Subject: VIRGIL C. SUMMER NUCLEAR STATION (VCSNS)
DOCKET NO. 50/395
OPERATING LICENSE NO. NPF-12
RESPONSE TO REQUEST FOR ADDITIONAL INFORMATION
REGARDING RESPONSE FOR GENERIC LETTER 96-06
(TAC No. M96872)
*"Assurance of Equipment Operability and Containment Integrity
During Design-Basis Accident Conditions"*

REQUEST FOR ADDITIONAL INFORMATION

Assessment for Transient Conditions in the V. C. Summer Station Service Water System During A Coincidental Loss of Coolant Accident and Loss of Off Site Power

Figure 6.2-7

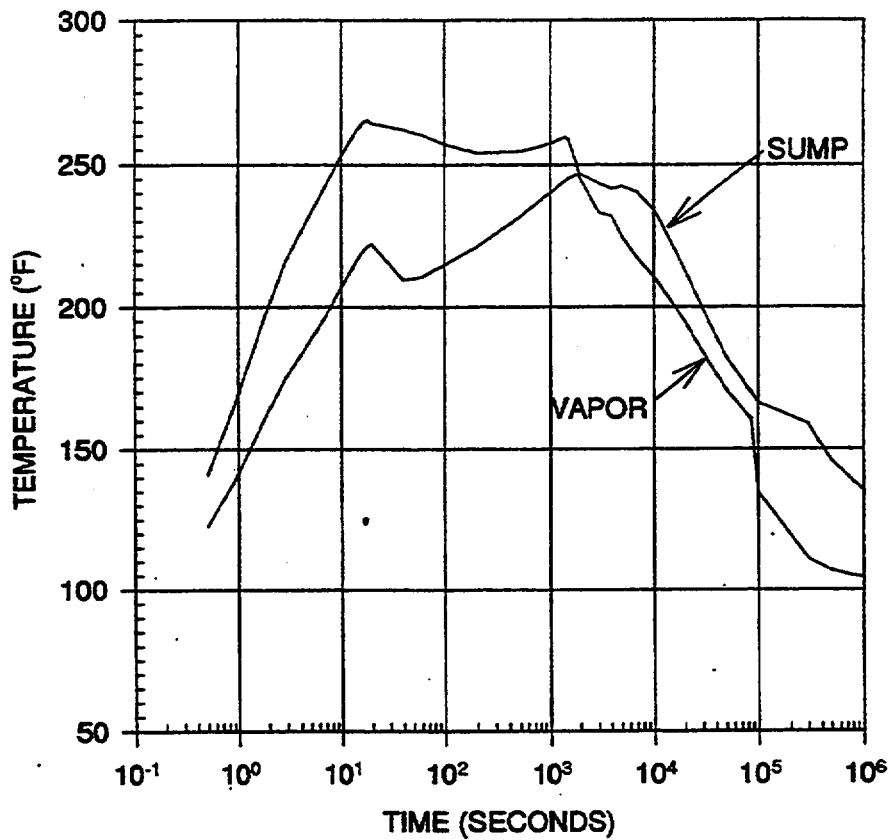
With regard to the two-phase flow analysis that was completed, the licensee did not address the reduction in containment cooling capacity that would result due to reduced flow caused by the increased friction of two-phase flow.

The hydraulic analysis of the RBCU steam voiding transient and refill conservatively assumed single-phase friction loss coefficients because the resulting higher fluid velocities increase the calculated water hammer pressures. The decrease in RBCU heat removal capability during two phase flow conditions is not considered significant with respect to the accident analyses and design basis because:

- The estimated time to refill the steam-voided portion of the RBCU system is approximately 33 seconds (SL-5102, Rev.0, Section 5.2.6).
- RBCU cooling flow is lost after 9 seconds and Service Water Booster pump power is restored 42 seconds into the accident scenario, creating a 33 second absence of flow. Flow to the RBCUs will be re-established within 3 to 5 seconds of pump restart. (SL-5102, Rev.0, Section 5.2.4).
- Containment air temperatures peak within 18 seconds of design basis LOCA initiation and remain above 250 F for over 1000 seconds. The approximate 33 second duration reduction in heat removal caused by two-phase flow effects is considered insignificant with respect to the total integrated heat removal from containment during the accident. (FSAR Figure 6.2-7, see Tab 2)
